**ATEC**  
FRAMEWORK DEVELOPMENT PLAN  
AURORA, COLORADO

Sheet Title  
CONTEXT MAP

MASTER PLAN NARRATIVE

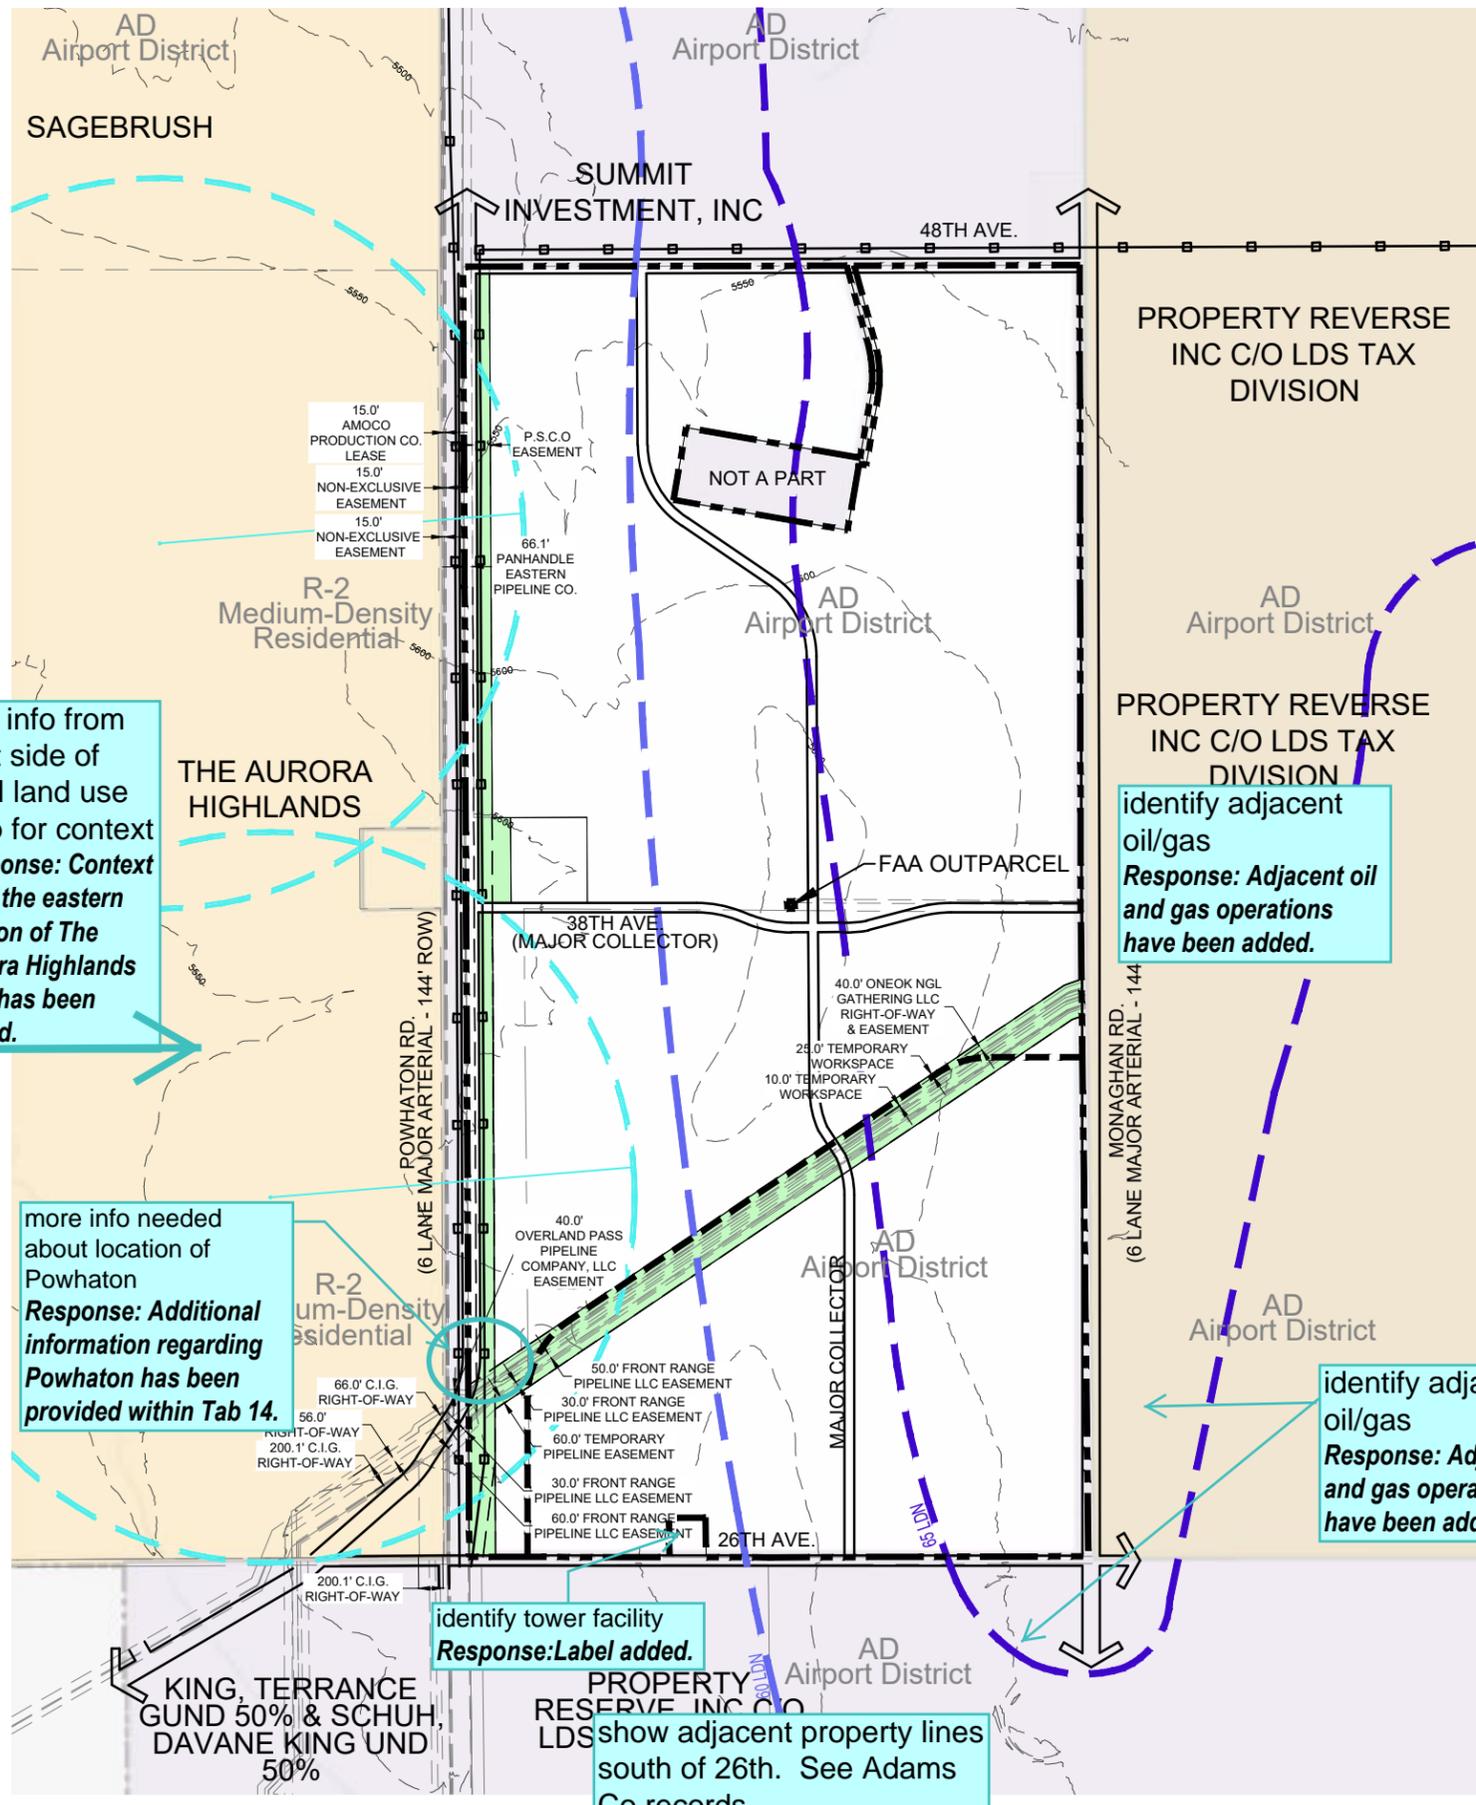
distinguish existing differently than proposed.  
**Response: Roadway has been updated to distinguish between existing and proposed conditions.**

add noise contours to legend  
**Response: Noise contour information has been included with the legend.**

identify adjacent oil/gas  
**Response: Adjacent oil and gas operations have been added.**

identify adjacent oil/gas  
**Response: Adjacent oil and gas operations have been added.**

make titles larger, typ.  
**Response: Titles have been enlarged.**

Add info from east side of TAH land use map for context  
**Response: Context from the eastern portion of The Aurora Highlands FDP has been added.**

more info needed about location of Powhatan  
**Response: Additional information regarding Powhatan has been provided within Tab 14.**

identify tower facility  
**Response: Label added.**

show adjacent property lines south of 26th. See Adams Co records  
**Response: Adjacent property lines have been indicated.**

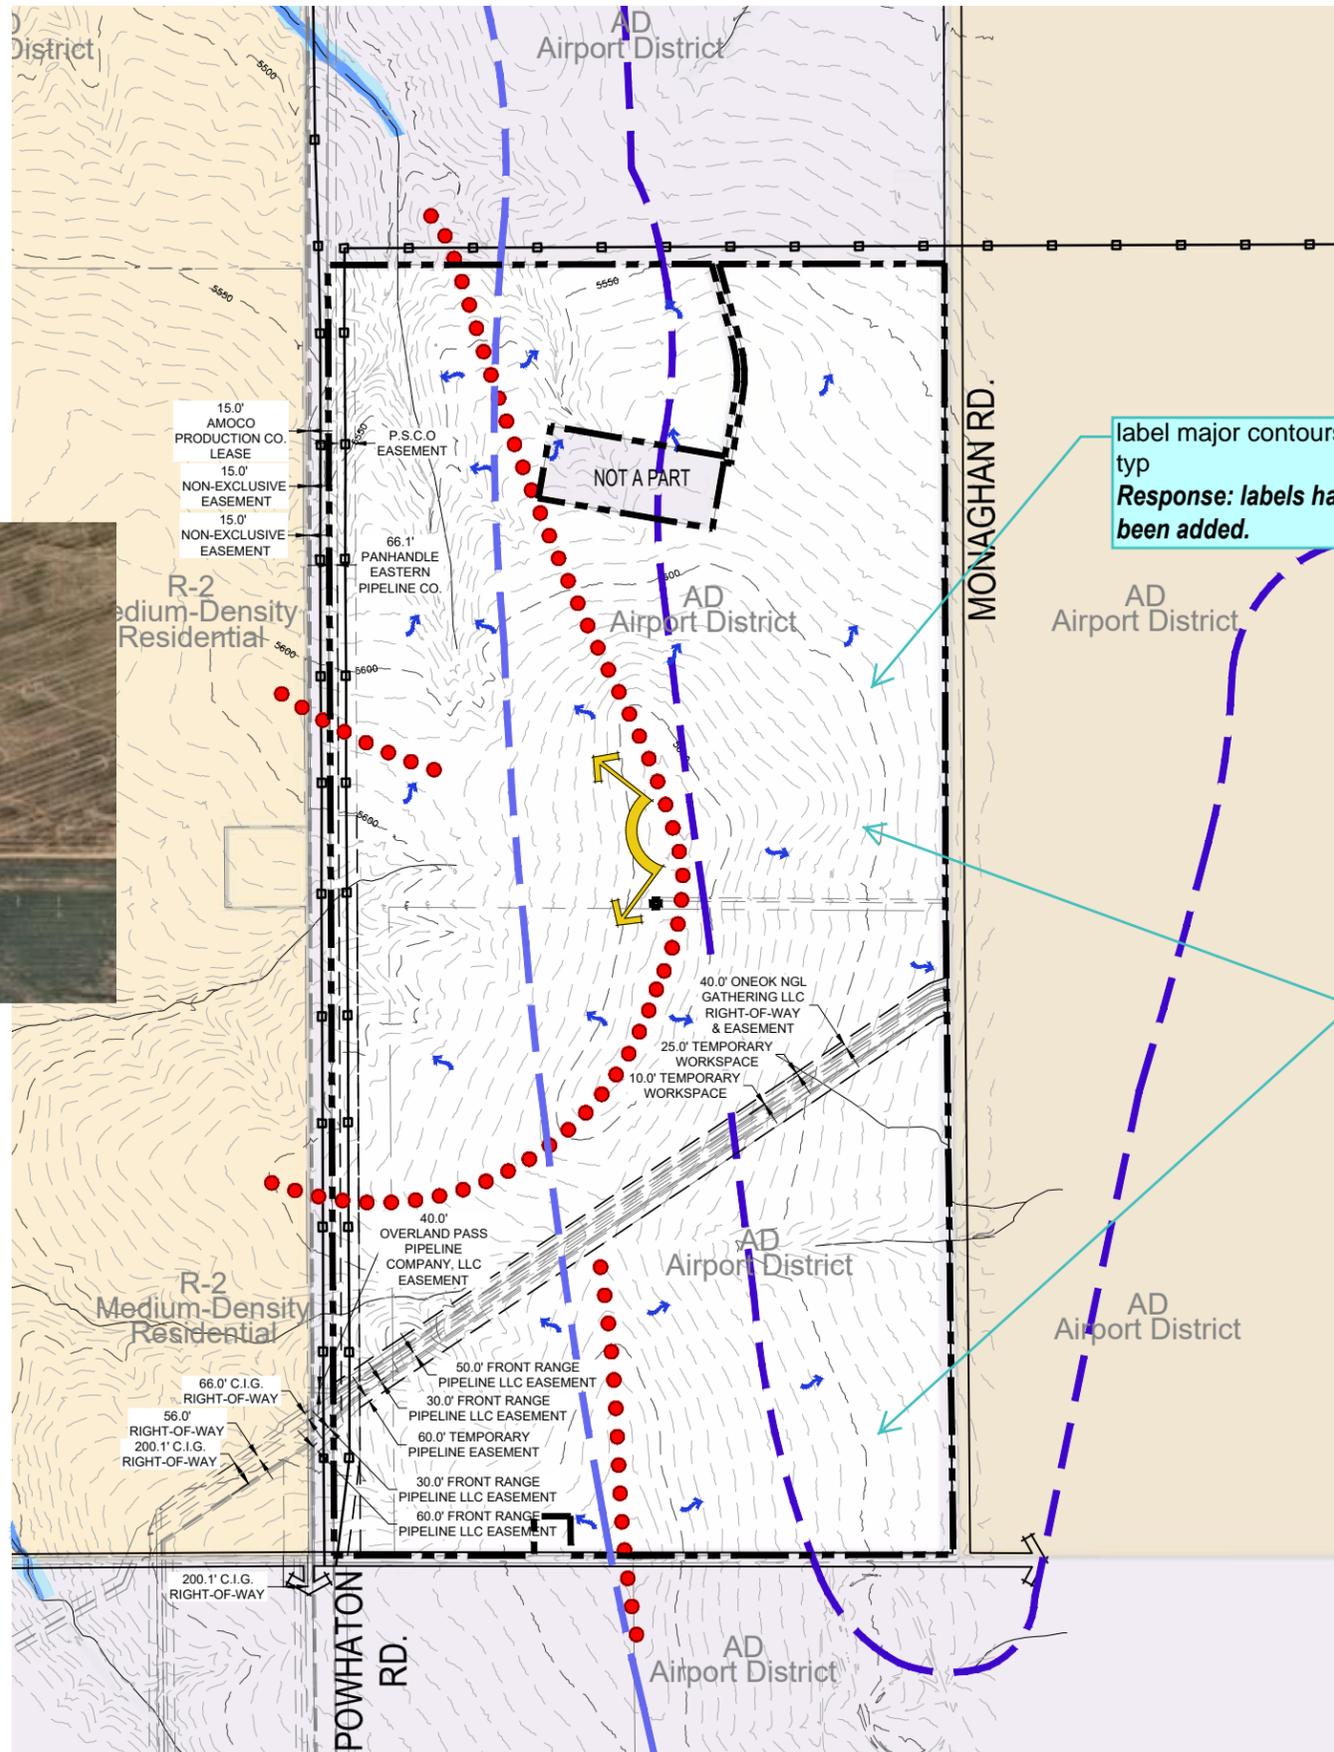
show existing buildings and oil and gas  
**Response: Existing buildings and oil and gas areas are now shown.**

label major contours, typ  
**Response: labels have been added.**

add noise contours  
**Response: Noise contours have been added.**

show existing on-site well pad sites  
**Response: Existing oil and gas located are shown.**

# Public Art Inspiration

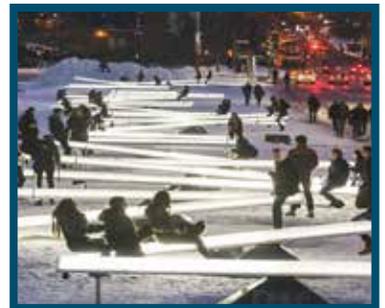
same images from TAH. Create a more "technical" modern theme  
Response: Images have been revised to reflect more of an industrial character.

OPEN SPACE, CIRCULATION AND VILLAGE PLAN

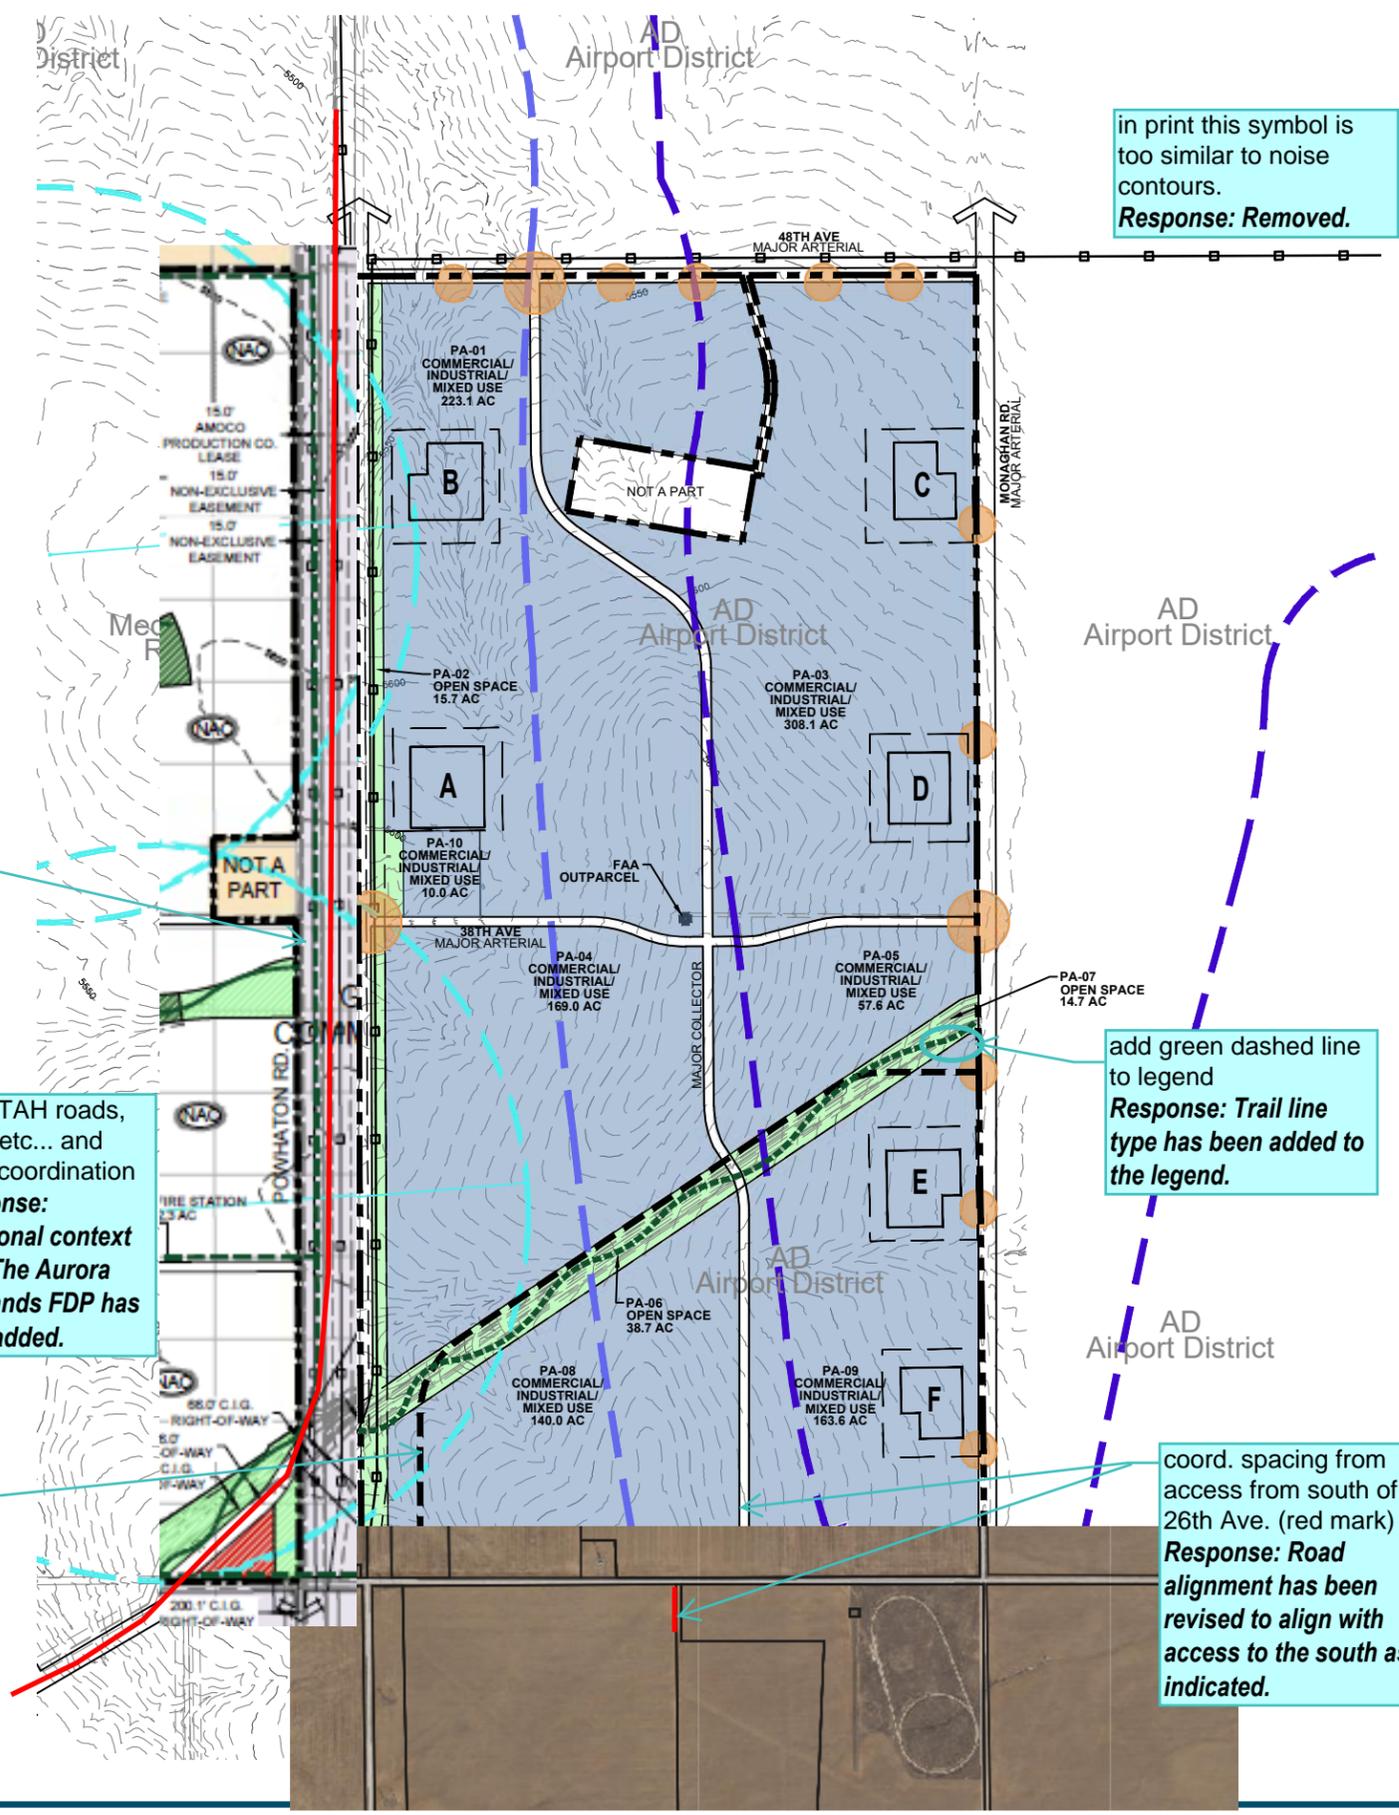
in print this symbol is too similar to noise contours.  
**Response: Removed.**

add noise contours dashed green line  
**Response: Noise contours have been added to legend.**

add green dashed line to legend  
**Response: Trail line type has been added to the legend.**

coord. spacing from access from south of 26th Ave. (red mark)  
**Response: Road alignment has been revised to align with access to the south as indicated.**

more info on location of Powhatan required. How will trail and pedestrian crossings be made  
**Response: Additional information regarding Powhatan Road has been provided in Tab 14.**

show TAH roads, trails, etc... and show coordination  
**Response: Additional context from The Aurora Highlands FDP has been added.**

internal road? criss-crosses trail?  
**Response: Roadway has been removed.**

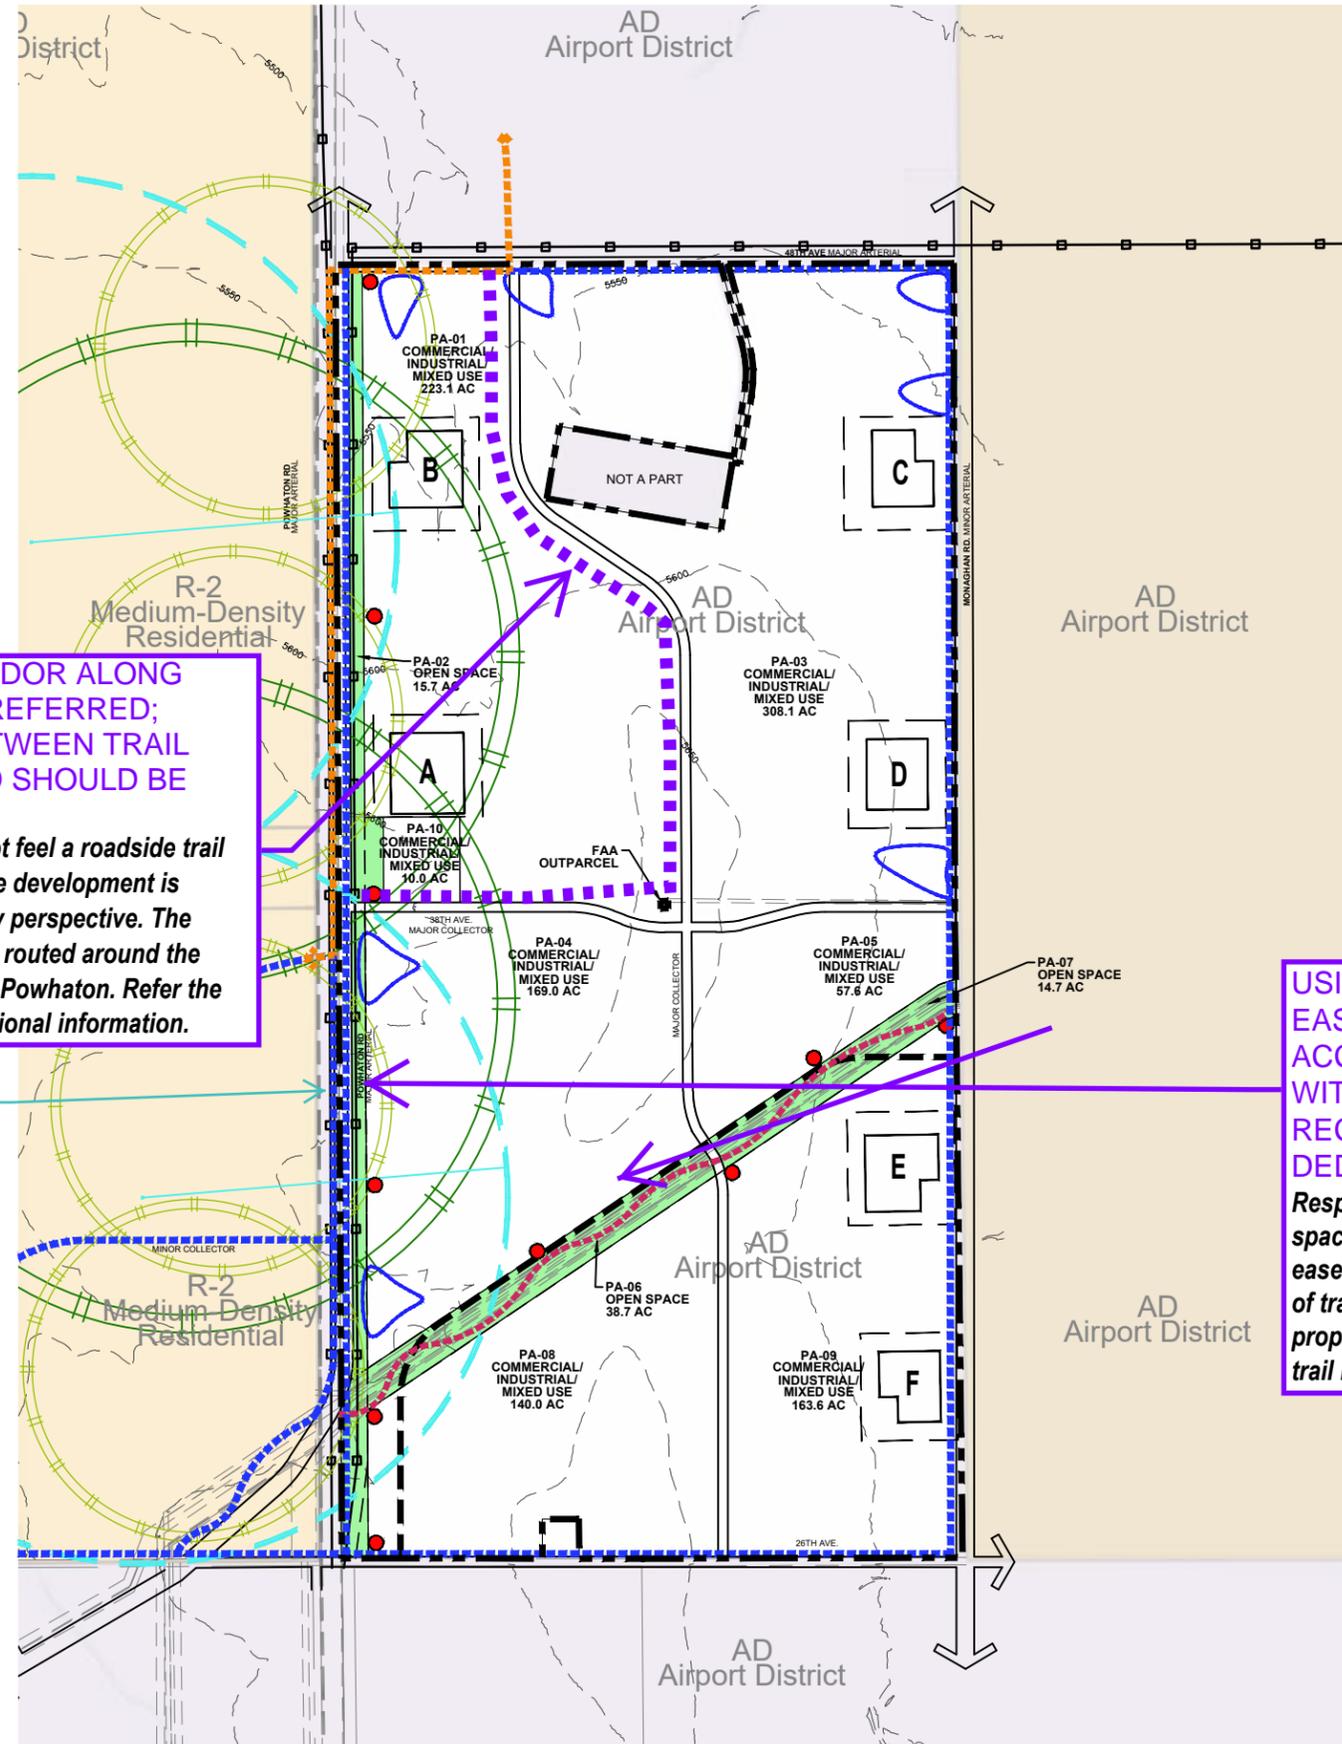
**IDEALLY, A TRAIL CORRIDOR ALONG THIS DASHED LINE IS PREFERRED; MINIMUM DISTANCE BETWEEN TRAIL CORRIDOR AND OIL PAD SHOULD BE 350'.**  
**Response:** The applicant does not feel a roadside trail corridor through the middle of the development is appropriate from a use and safety perspective. The revised trails map shows the trail routed around the development on the West side of Powhaton. Refer the Powhaton cross section for additional information.

the plan for Powhaton is limited access major arterial. How are the trail connections and crossings going to be handled? How will the trails be incorporated into the street profile?  
**Response:** Trail crossings along Powhaton Road are proposed at designated, signalized intersections. Additional information related to Powhaton Road and trail corridors within the ROW are illustrated in Tab 14.

**USING EXISTING UTILITY EASEMENTS FOR TRAILS IS ACCEPTABLE, BUT THE AREA WITHIN EASEMENTS CANNOT RECEIVE CREDIT TOWARDS DEDICATION REQUIREMENTS.**  
**Response:** Comment acknowledged. Open space credit is requested within the CIG easement transversing the site with the addition of trail nodes located periodically along the proposed alignment and will be similar in size to trail nodes proposed with the TAH FDP.

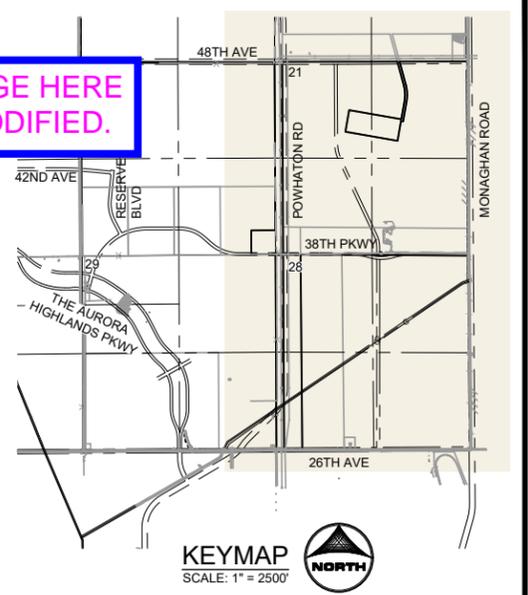
Will the creek be modified to avoid the pad site?

The Powhatan Road alignment needs to be consistent with TAH PIP. Improvement needs to be shown, but indicated to be done by TAH? Again addressing if PA-4 develops prior to TAH triggers for Powhatan

Please use language from typical sections or add street names to the typical sections

THE ALIGNMENT OF POWHATON ROAD IS CONSISTENT WITH THE APPROVED TAH PIP. LANGUAGE HAS BEEN ADDED TO REPORT FURTHER EXPLAINING PHASING.
